EMBASSY OF THE UNITED STATES OF AMERICA  
REQUEST FOR QUOTATION N. 19H08021Q0005  
FUEL – BULK SUPPLY AND DELIVERIES  
QUESTIONS AND ANSWERS

Image 2/3

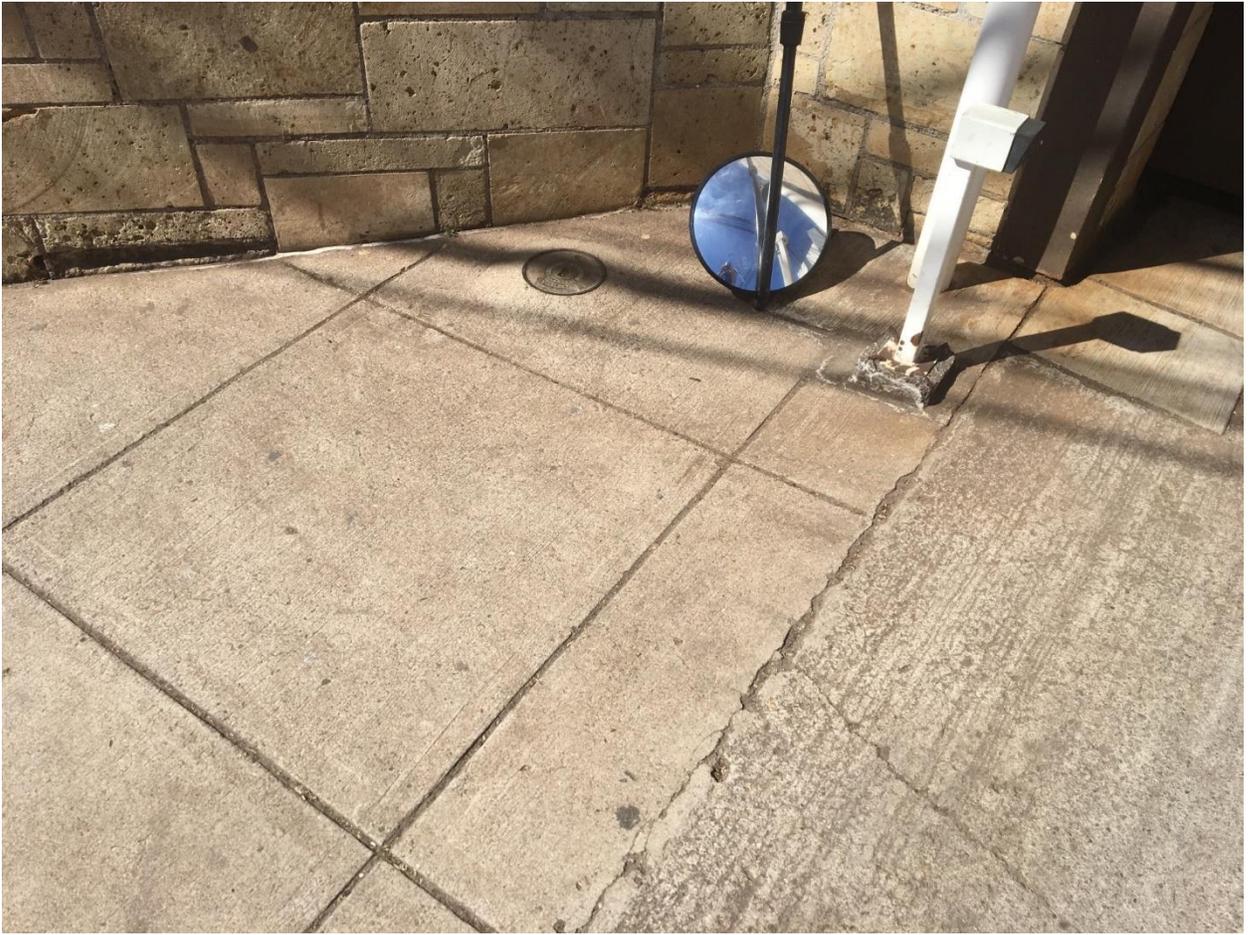
**Q 4.** Could you please share images of the fuel storage tanks and the fuel unloading pipes (pipes where truck will ensemble to discharge fuel to the storage tank)? Please, confirm the fuel capacity per tank.

- **NOBX (New Office Building) = capacity of 3,600.00 gallons**  
The fuel connection is outside the perimeter wall. The fuel trucks must park adjacent to our sidewalk and discharge by gravity into our storage tank located at the ground floor. There is a second connection at our compound for PCC generator and it is discharged in the same manner. We normally request 2000 or 1000 gallons deliveries.
